MACROINVERTEBRATE ASSESSMENT OF PARR RESERVOIR AND
MONTICELLO RESERVOIR NEAR THE VC SUMMER NUCLEAR STATION
OPERATED BY SOUTH CAROLINA ELECTRIC AND GAS COMPANY,
FAIRFIELD COUNTY, SOUTH CAROLINA

SEPTEMBER 2008

VCSNS UNITS 2 and 3

Response to NRC Information Needs Item

OVERLAY MAP

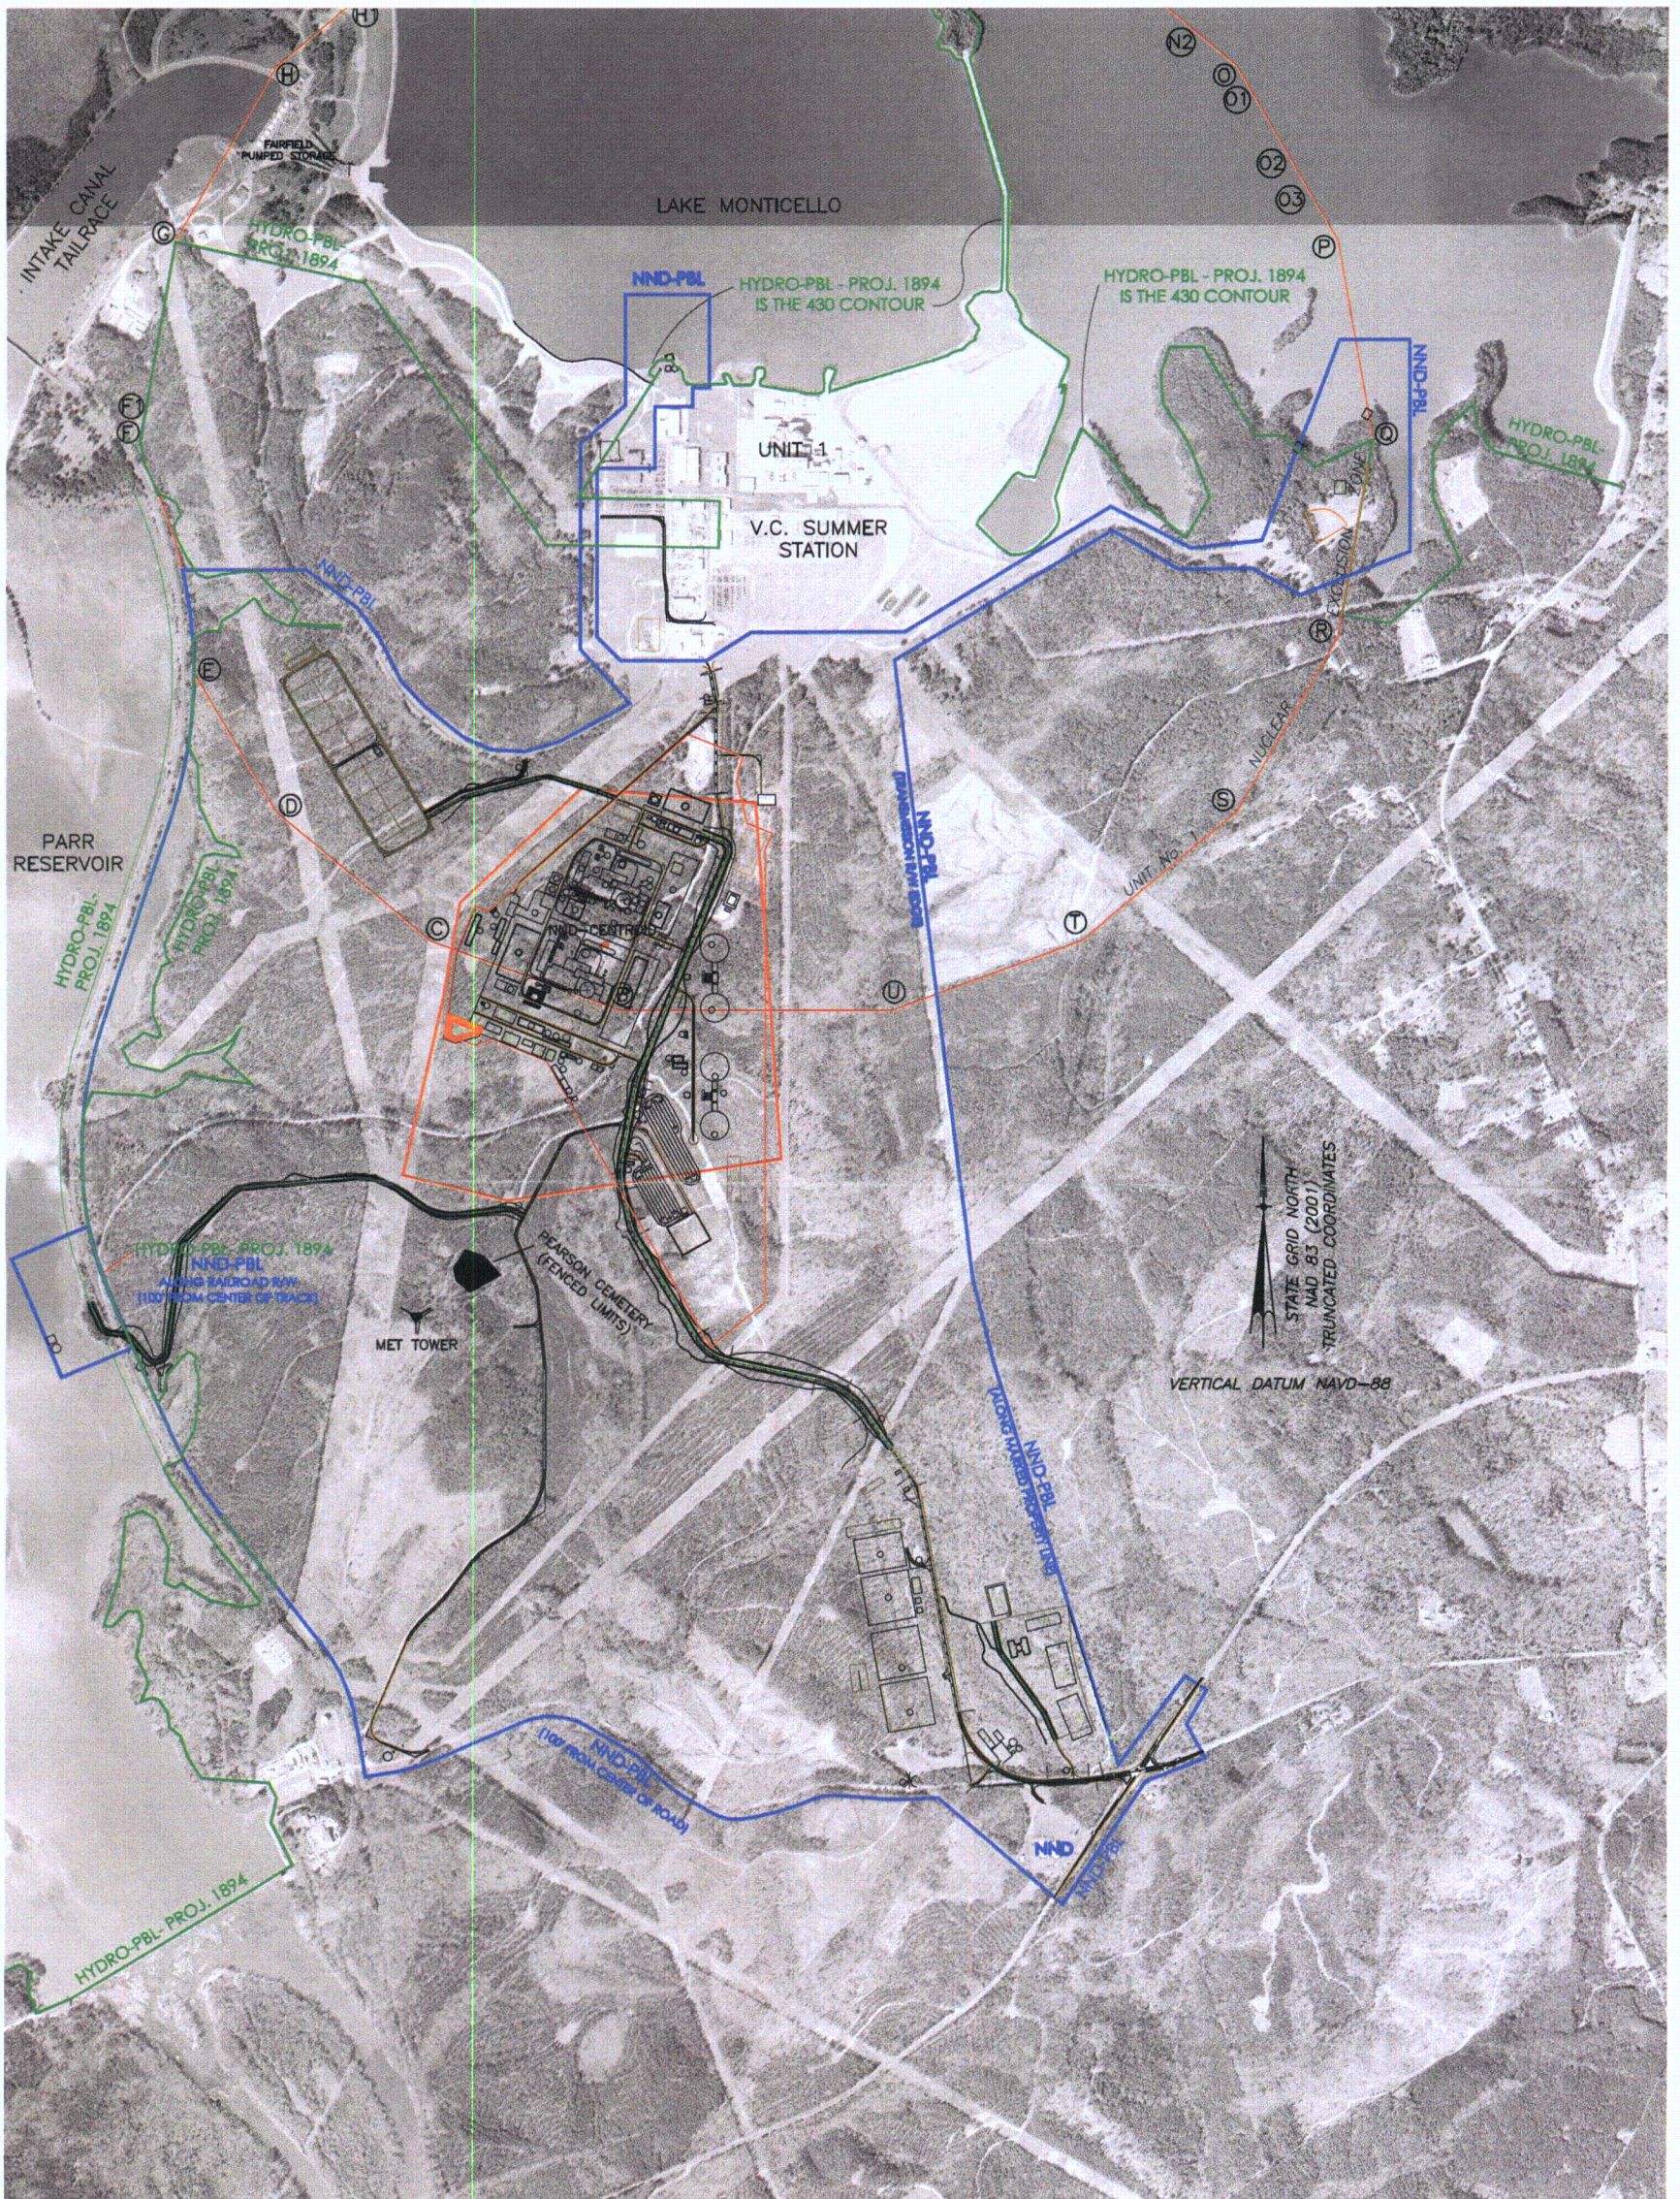
Make available someone who can discuss ownership of the land on which the VCSNS is located.

Provide confirmatory statement and map showing property boundaries (see G-6).

As discussed during the site audit, SCANA owns all of the land on which the VCSNS is located. Santee Cooper, as a partner in the nuclear projects, is a joint owner of all land that has nuclear related facilities. Attached is a map that shows the NND-PBL (e.g. the New Nuclear Deployment Project Boundary Line) marked in blue. The NND-PBL is the maximum expected area of project impact.
